# Design Review Board

### DESIGN REVIEW BOARD – URBAN DESIGN PANEL

September 2, 2021

**Planning Staff Report to  
Design Review Board - Urban  
August 27, 2021**  
*for the September 2, 2021 Public Hearing*

### WEST WALL IMPROVEMENTS

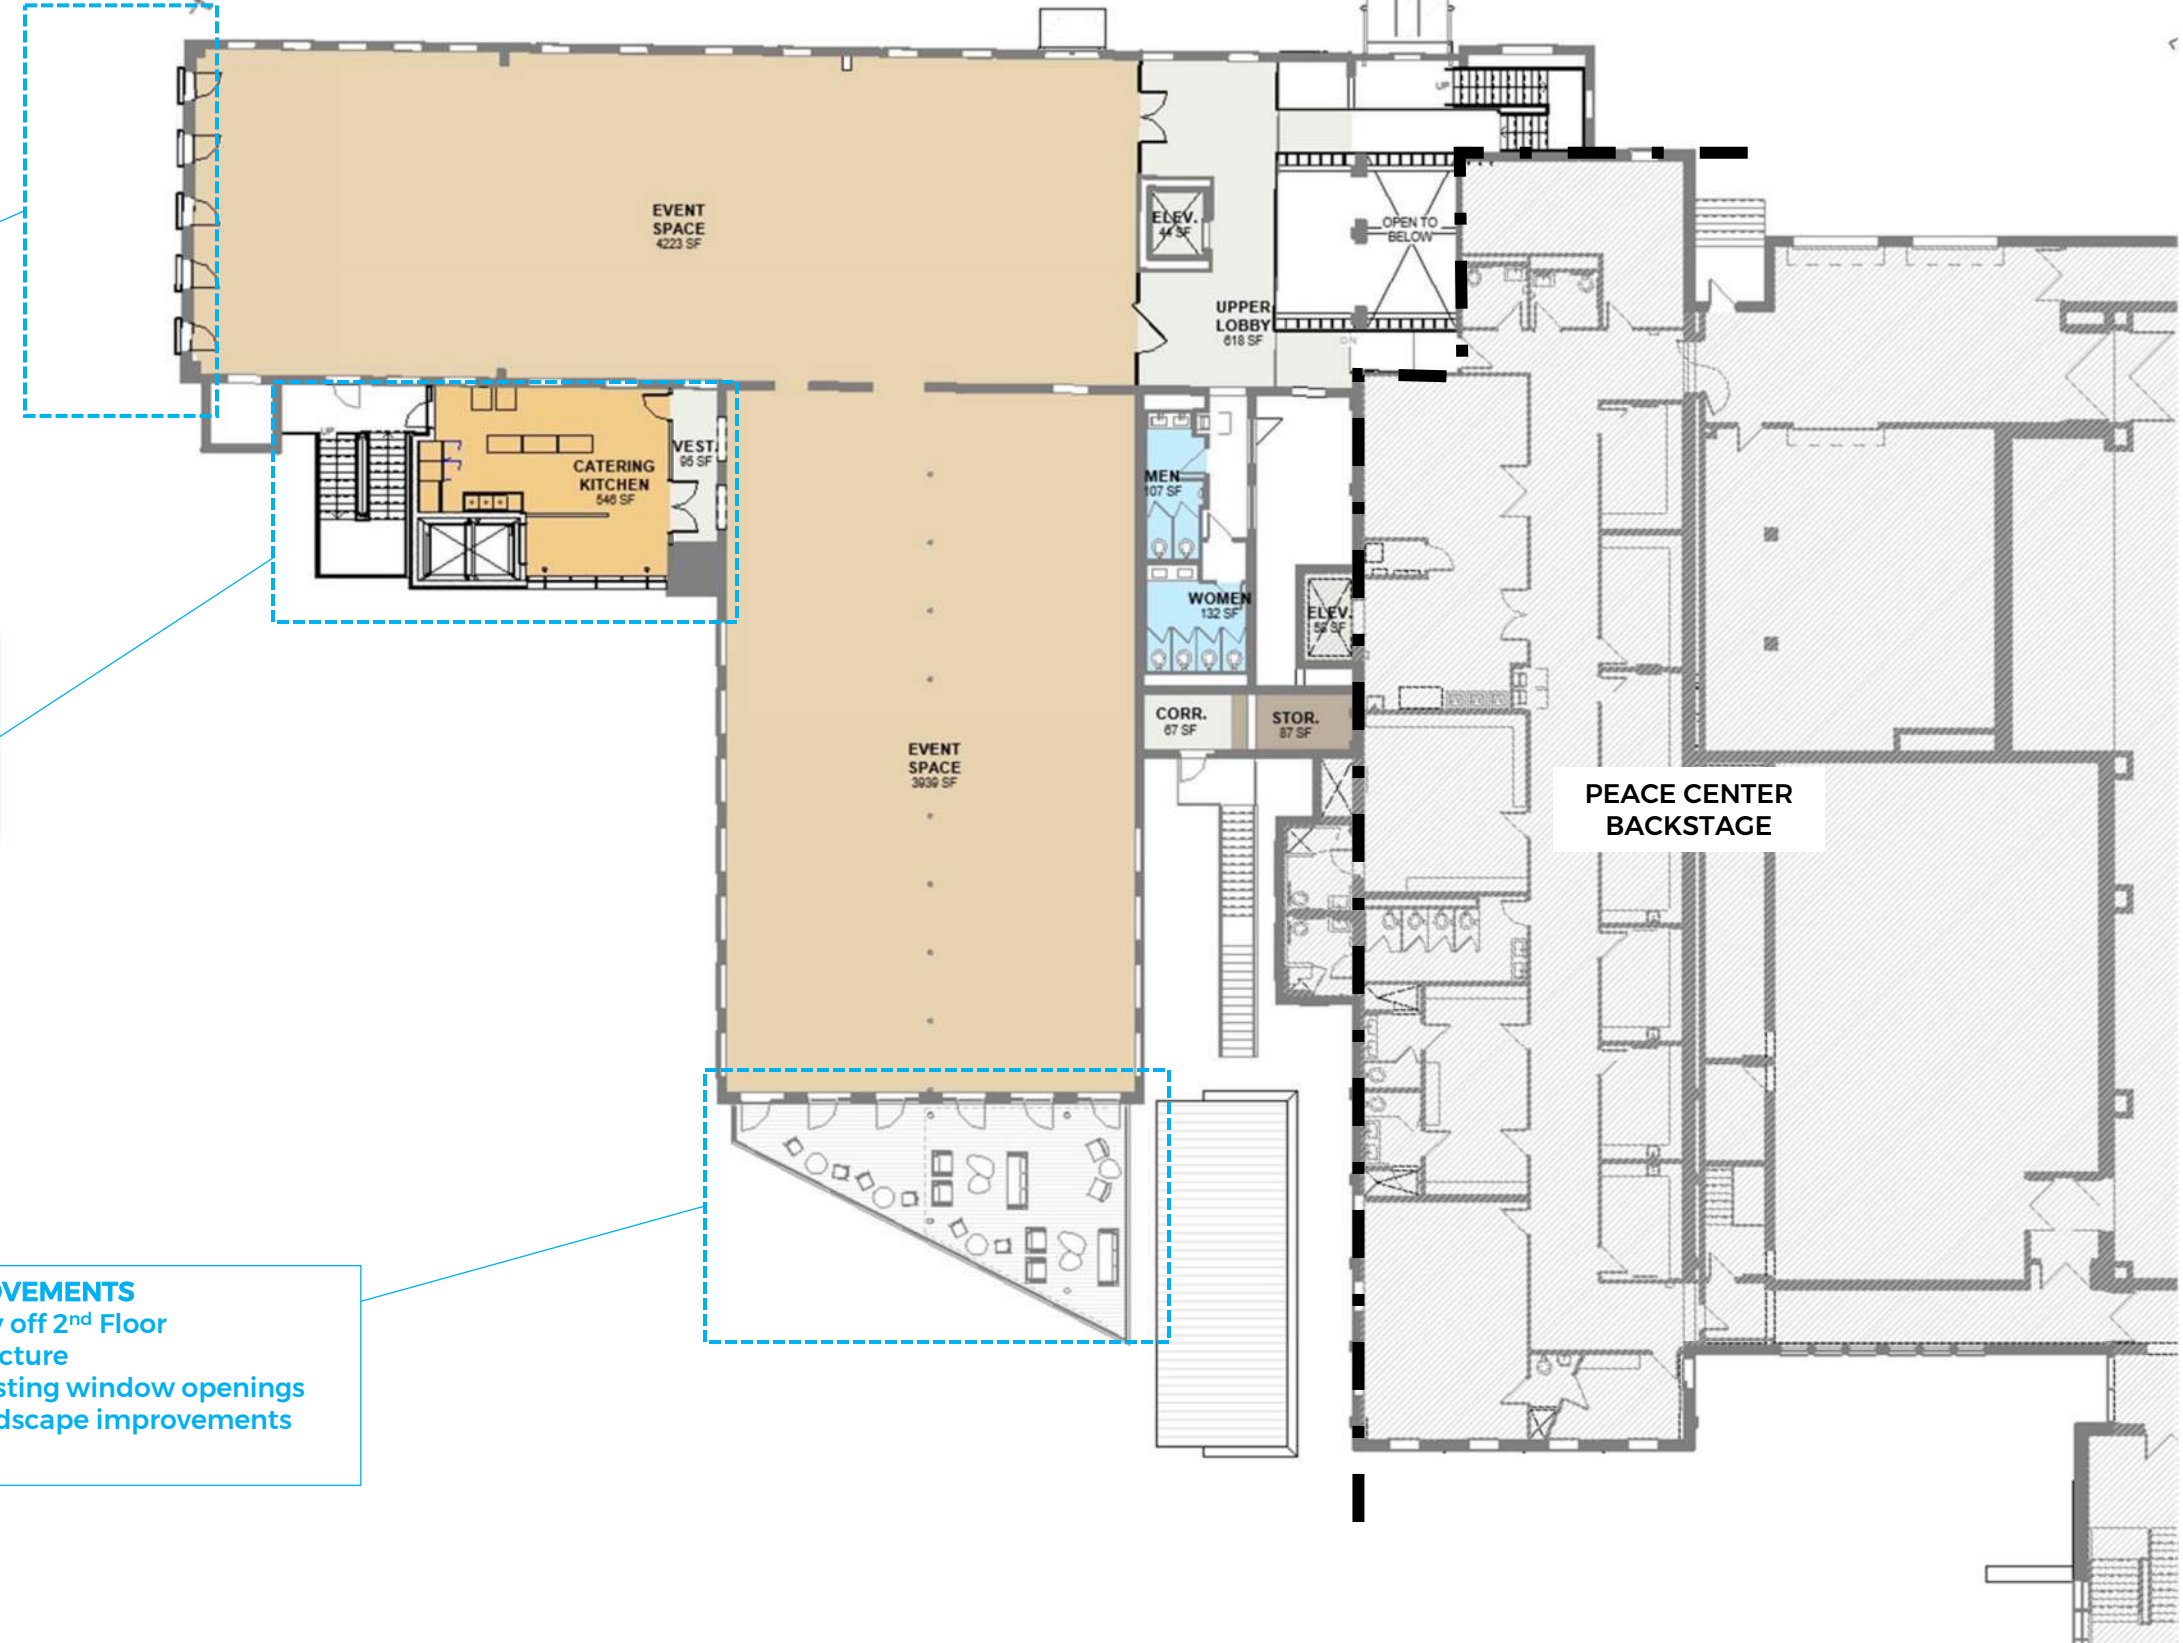
Five Juliet balconies are proposed on the second floor of the west façade. New aluminum doors are proposed, within the existing window openings on the second floor, to provide access to the balconies.

- Level 2 Juliet Balconies
- New doors in existing window openings
- New site wall and landscape improvements (under design)

Staff finds that the proposed modifications are consistent with the applicable design guidelines and will improve the appearance of the south and west façade of the Huguenot Mill building. Staff also finds that the proposed terrace and elevated balcony will help to create a more welcome pedestrian environment along this portion of the Reedy River.
